7. Blessing Estates; KPB File 2025-072R1
Mullikin Surveys / Roderick
Location: North Fork Road & Incline Street
Anchor Point Area

**ITEM #7 - PRELIMINARY PLAT
BLESSING ESTATES**

KPB File No.	2025-072R1
Plat Committee Meeting:	April 13, 2026
Applicant / Owner:	Paul Roderick / Anchor Point, Alaska
Surveyor:	Christopher Mullikin / Mullikin Surveys LLC
General Location:	Near mile 1.7 North Fork Rd, Anchor Point

STAFF REPORT

PRELIMINARY PLAT

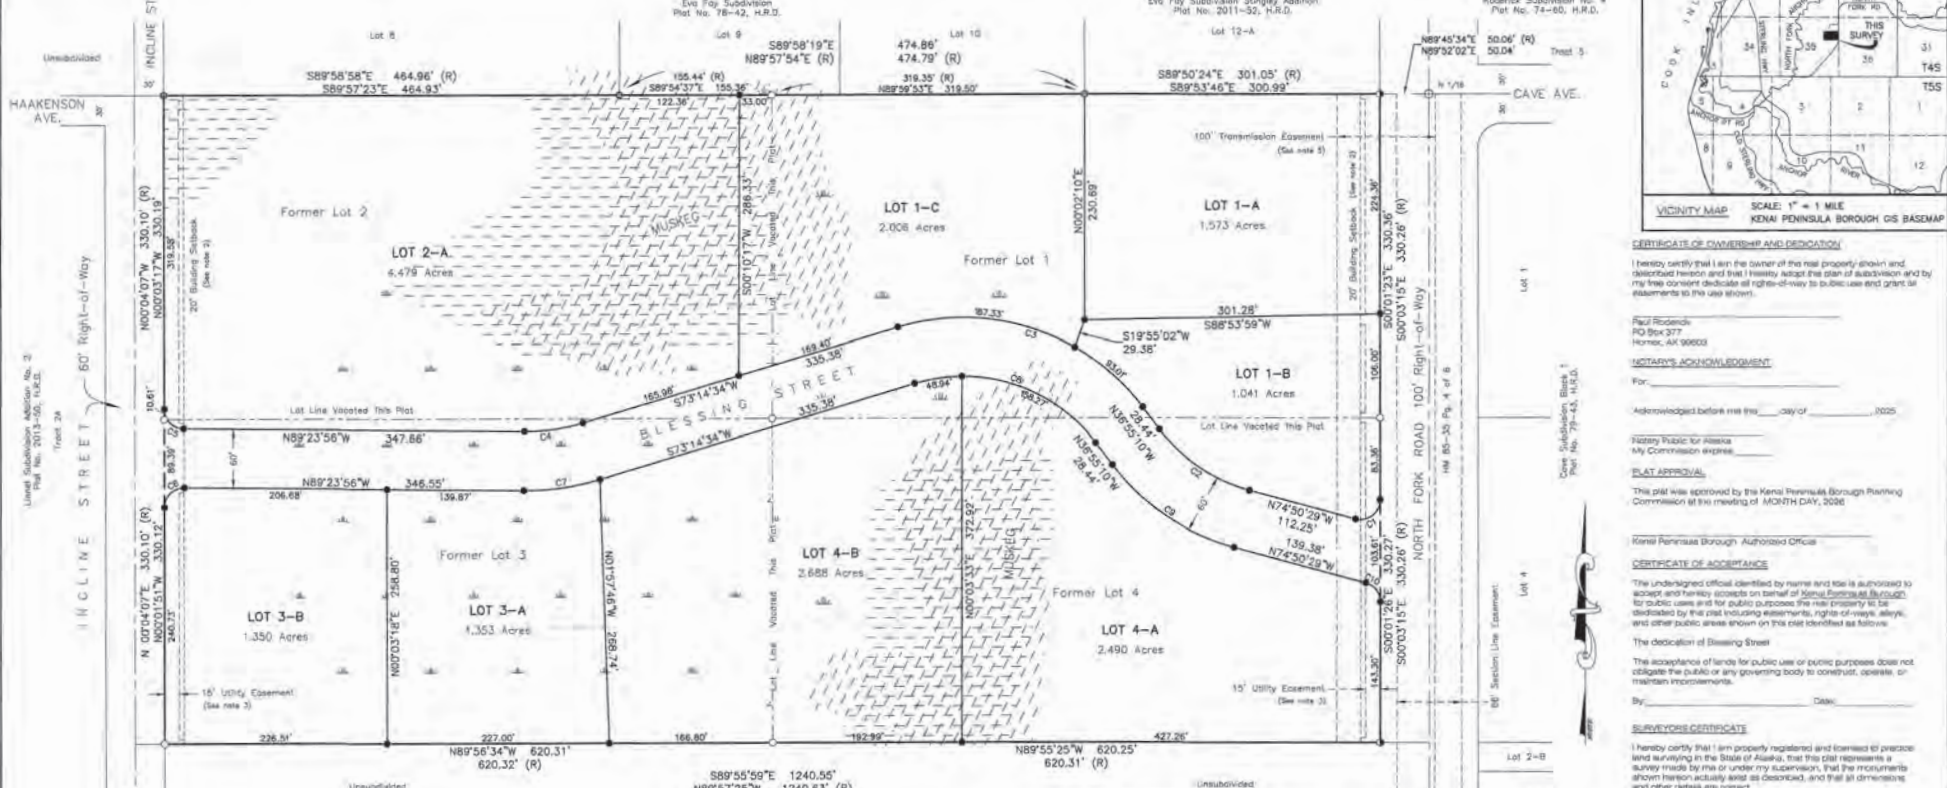
The 100' transmission line is shown being located centered on the existing poles and noted at plat note 5. The 15' utility easement extending to 20' at sidelines need to be corrected on the east line as it does not cross the proposed road and needs turns at sidelines.

The 10' utility easement along rights-of-way and extending to 20' at sidelines being proposed by this plat needs to be shown on the plat along with the 20' building setback line.

Wastewater disposal note will need to match the note in the report.

In the Plat Approval, add the date of April 13, 2026

In the Notary's Acknowledgement the year is 2025, change to 2026.

Modify the KPB File no to 2025-072R1

In the legend, in the Wetlands Area Field Measured if is spelled incorrect. Measred.

Show Incline St on the vicinity map and any rod needed to get to Incline

Show all utility easement and setbacks on the drawing

- To the northeast the lot label need changed to 74-1960
- H. Approximate locations of low wet areas, areas subject to inundation, areas subject to flooding or storm water overflow, and the line of ordinary high water. This information may be provided on an additional sheet if showing these areas causes the preliminary plat to appear cluttered and/or difficult to read;
Staff recommendation:
Wetlands shown are only from the National Wetland Inventory, wetlands from KWF Wetlands Assessment need added to the drawing.
- N. Apparent encroachments, with a statement indicating how the encroachments will be resolved prior to final plat approval;
Staff recommendation:
Structure from the south appears to encroach across south line into plat, surveyor should verify and report results to staff.

SEA REVIEWED - SEE COMMENTS
 Scott Huff 4/1/2026
 Land Management Officer

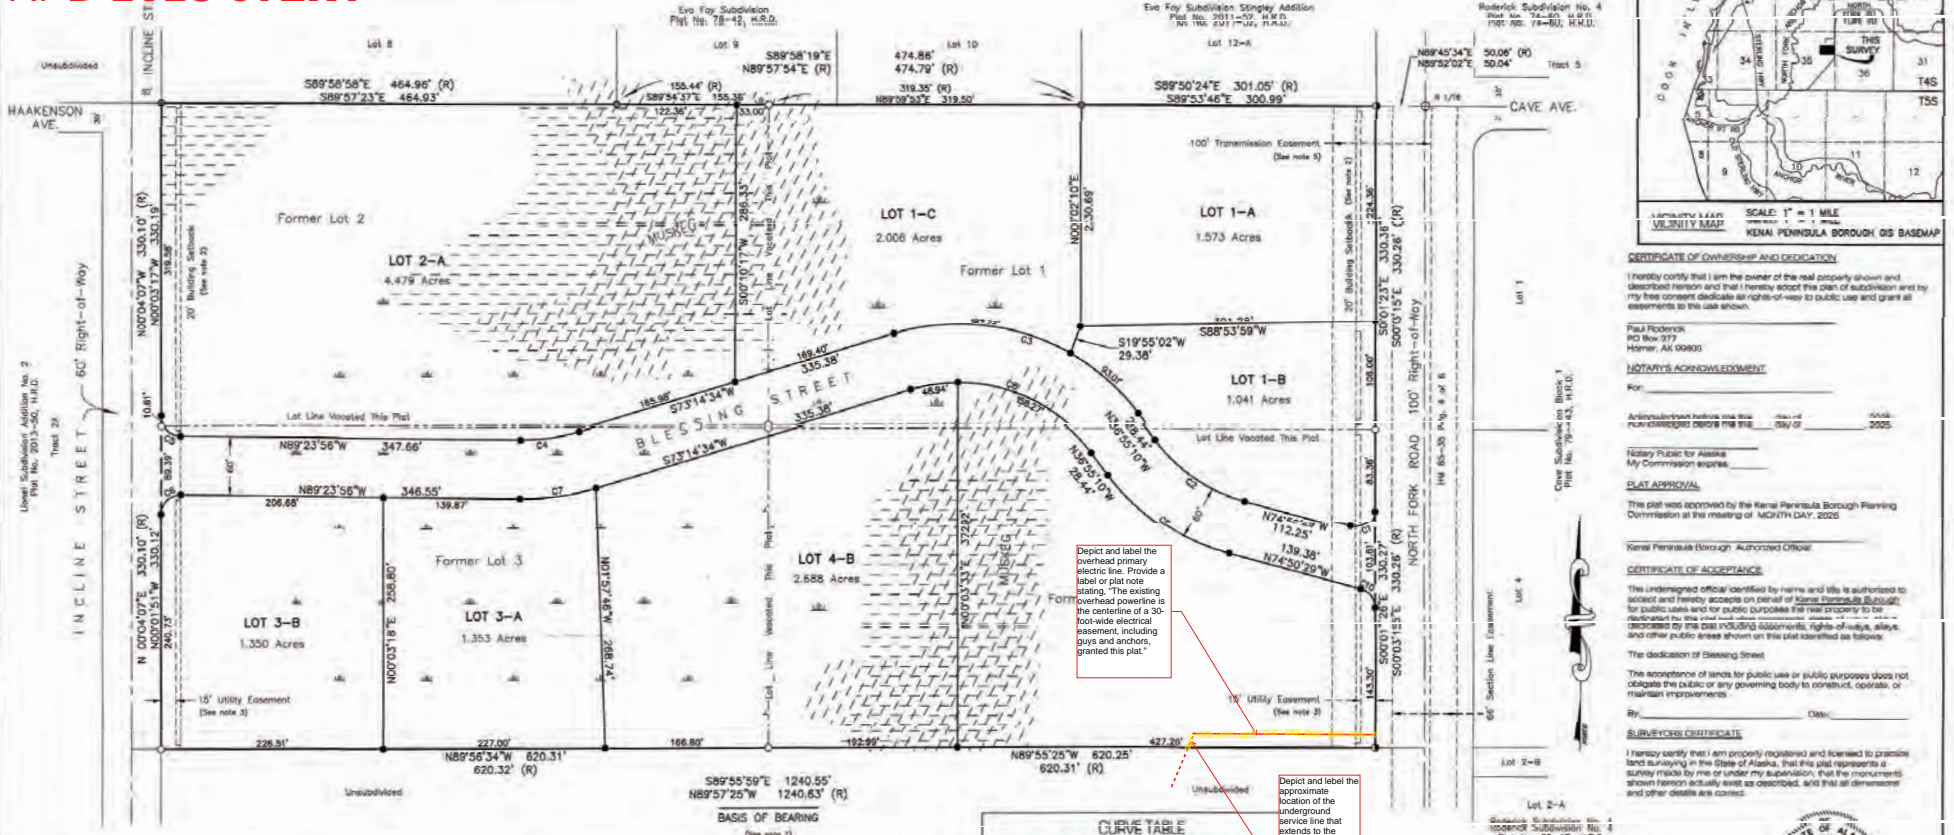
Depict and label the overhead primary electric line. Provide a label or plat note stating, "The existing overhead powerline is the centerline of a 30-foot-wide electrical easement, including guys and anchors, granted this plat."

Depict and label the approximate location of the underground service line that extends to the south. Provide a label or plat note stating, "The existing underground powerline is the centerline of a 15-foot-wide electrical easement, including pedestals, granted this plat."
